MEMORANDUM

FROM: DEPARTMENT OF FISH AND GAME

SUBJECT: Timber Harvesting Plan 1-88-011 MEN  
Barton Gulch, Navarro River, Mendocino County

MAP TO ACCOMPANY  
TIMBER HARVESTING PLAN  
Giacomini - West Barton Gulch - Louisiana Pacific

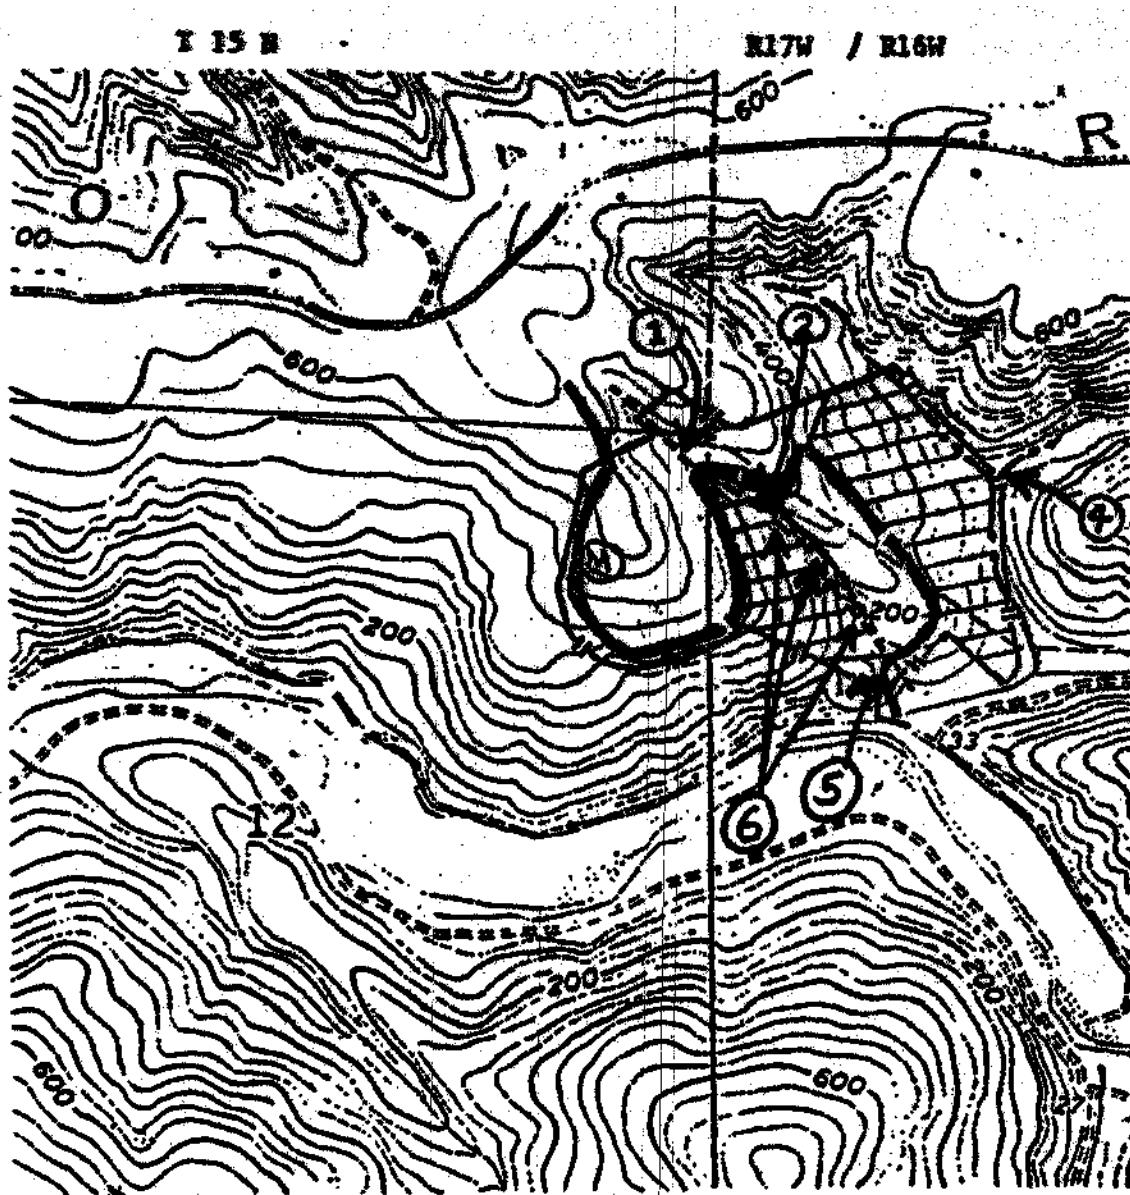
1. Portions of the seasonal road (above Point M) contained waterbreaks that had been breached by traffic. They had remained in this condition after the most recent rainfall. This included at least one weekend. The RPF indicated these waterbreaks would be reinstalled or repaired following the on-site inspection on February 1, 1988.

2. At Area 1, the Class II watercourse extends upslope to this point approximately 200 feet upslope of the existing truck road. There is a six foot "nick point" at this location. At present-flow begins at this point. Pools and vegetation remain dense downstream past the slide. At the slide flow is underground surfacing at the base of a ten foot plus falls in the watercourse near the slide at Point 2. Several large second growth Redwood have fallen across the watercourse at Point 2. These can be removed by cable machine. There is access on benches for tractors north and east of the watercourse downstream from the slide at Point 2. The watercourse is deeply incised in this area. The incised slopes will not require tractor operations other than end-lining from the WLPZ.

3. The KPF indicates a Class I watercourse up to Point 4. No fish were observed in this area, however, fish have access to this area during the winter period. The area upstream of Area 4 contains meandering channels where gravel has settled. The source of this gravel was not located during this inspection, however, some stream meandering and sidecutting was observed upstream of Area 4. Extensive erosion on the public road north of this area (Navarro Ridge Road) has been noted in the past. It is not known if this erosion has contributed to erodible materials mentioned above.

4. A wet area with a one to two foot scarp was noted at Area 5. The RPF has this flagged off of the THP area, however, It appears as indicated on the attached map. Point 5 should either be shown on the map or the map changed to reflect conditions as flagged on-site.

5. Point 6 indicates areas, northeast of the added Class II watercourse, where steepness of slope indicates this is a moderate erosion hazard rated area. The watercourse is deeply incised in some areas (10+ feet) and contains a lens shaped channel with underground flow in other areas. The channel transports bedload soil downstream of Point 1 with considerable materials transported downstream of the slide at Point 2. Almost all of the gravel settles on the flat in a delta at the edge of the flood plain. Extreme high water has flooded Highway 128 in the past. The culvert under Highway 128 is accessible to fish during normal winter flows.

6. Between Points 2 and 5, concentrated surface flow was carried in the inside road ditch and along the road surface for extended distances without the benefit of relief. This will be addressed by the Geologist and/or CDF in their- reports.

1. Extend the Class II watercourse up to Point 1.
2. Trees marked for leave shall be marked at the base of the tree.
3. Either map wet area and scarp at Area 5 or change map to reflect flagged area on-site.
